SUSPENSION—CNG EXTENDED RANGE VEHICLES SITTING LOW IN REAR	Article No. 02-18-6

FORD: 1998-2002 CROWN VICTORIA

Figure 1 - Article 02-18-6

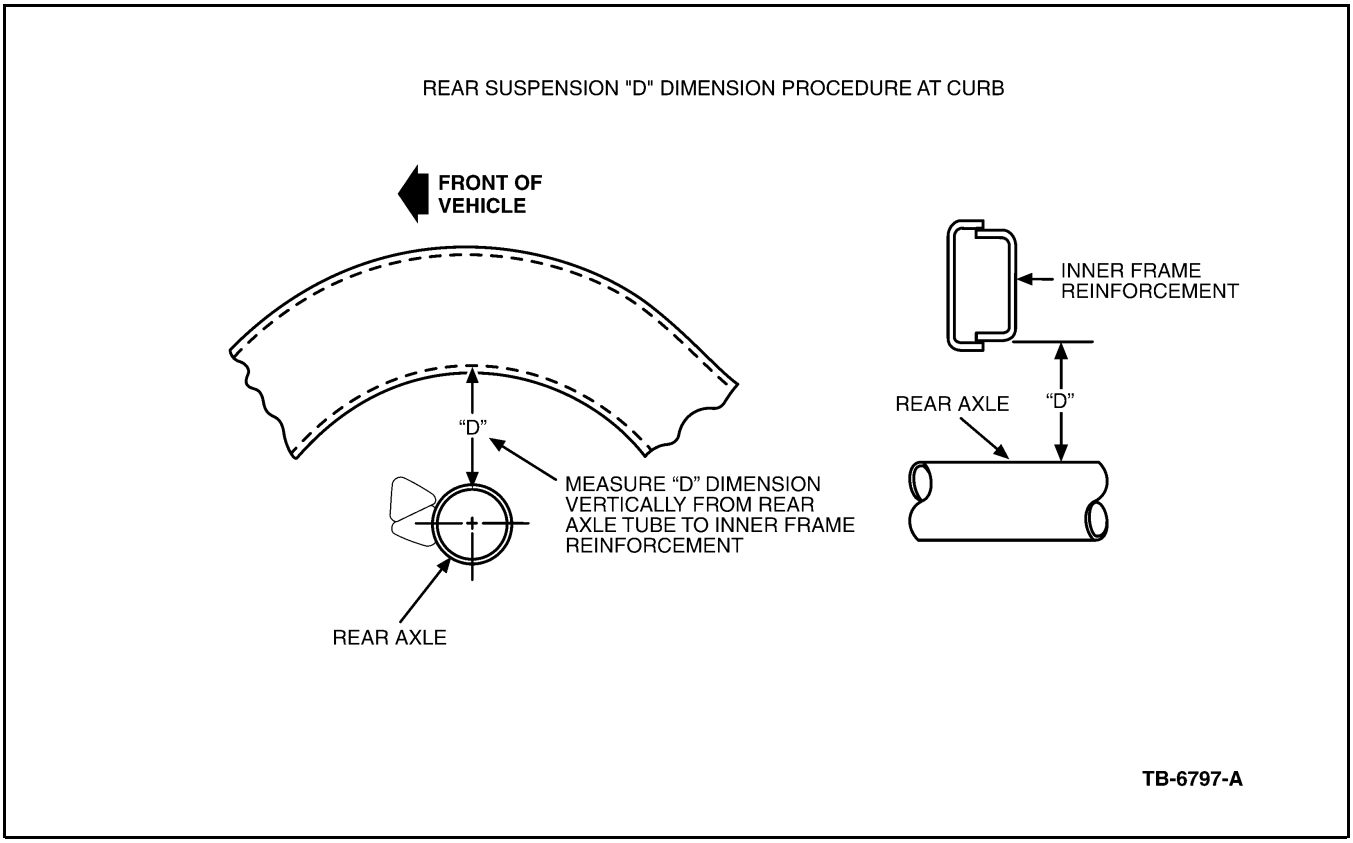
Some CNG Extended Range vehicles may appear to sit low in the rear. This may be caused by the rear springs.

a. Measure from the top of the axle tube to the underside of the frame (Figure 1).

b. The rear ride height measurement should be 5.2 inches (+/- .3) or 137 mm to 153mm.

c. If below specification, Replace rear springs with updated part D9AZ-5560-AE.
